DUKE POWER COMPANY

Re: McGuire Nuclear Station
Docket Nos. 50-369, 50-370

AN ANALYSIS OF HYDROGEN CONTROL MEASURES AT
McGUIRE NUCLEAR STATION

Insertion Sheet
Revision 5
November 5, 1982

Figure 1

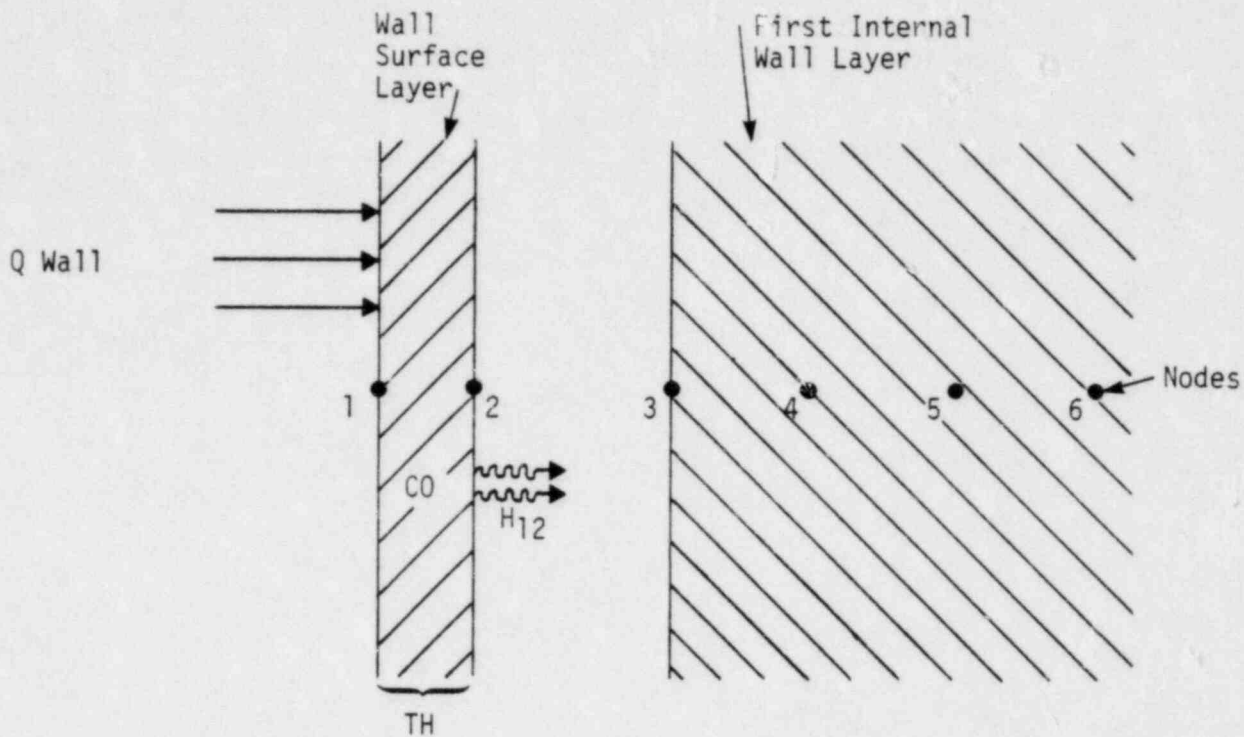
- 7) For the internal heat transfer model, provide additional details with regard to:
- a) The procedure for updating the surface temperature of a wall with two nodes in the surface layer; and

Figure #1 presents the basic geometry of this special modeling case. Although a coat of paint could be modeled as a three node surface layer, the time step required to obtain solution stability would be prohibitively short. The two node model is not subject to this problem. The surface temperature of a two node wall surface layer is computed after a heat flux has been determined in a "new" time step:

Equation B-17 (OPS-07A35) is used to compute the surface node temperature for the first wall layer comprised of three or more nodes. (In the case of Figure #1, this situation would correspond to node 3.) This equation is also used whenever heat is transferred between wall layers.

Figure 1

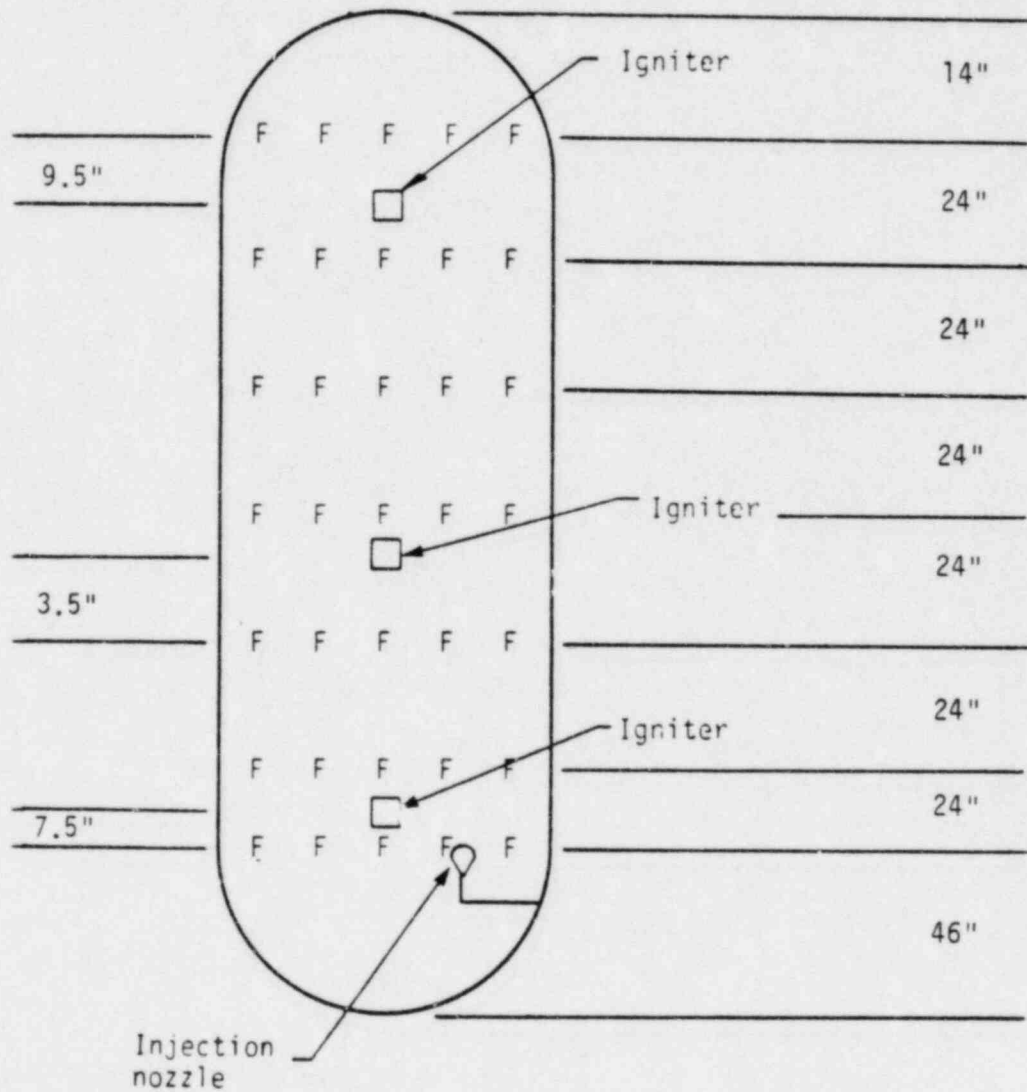
Tables summarizing pre- and post- burn conditions, igniter locations, maximum measured pressure rise, adiabatic pressure rise, completeness of burn, and estimated flame speed. These tables should be keyed to and cover all of the tests committed to in the test in matrix (tables 1 - 4 Appendix A.1 of the fourth quarterly report on the TVA research program, June 16, 1981) plus any additional AECL tests conducted under this program. Of particular interest to the staff are the results of the 8.5% H₂ test with 30% H₂O and top ignition. Discuss your plans for conducting tests at steam concentrations above 30%, as committed to in previous quarterly reports;

- ii) The Acurex test vessel was not instrumented to obtain data on localized flame speeds. However, by knowing the ignitor location and using the resulting pressure traces, "average" flame speeds were calculated. These flame speeds were determined by assuming that the flame front propagated through the test vessel as a disc. The base of a pressure spike represented ignition and the peak represented quenching of the flame. This approach was valid only for tests where discrete burns were observed and propagated throughout the entire vessel. Propagation distances were obtained from Figure 1 and propagation times were obtained from Appendix 2H. The quotient of these two values yielded the average flame speed. Although localized flame speeds were expected to be higher, for the purposes of comparing observed speeds to the average speeds used in containment analyses, this computational approach was believed to be adequate. The calculated average flame speeds were:
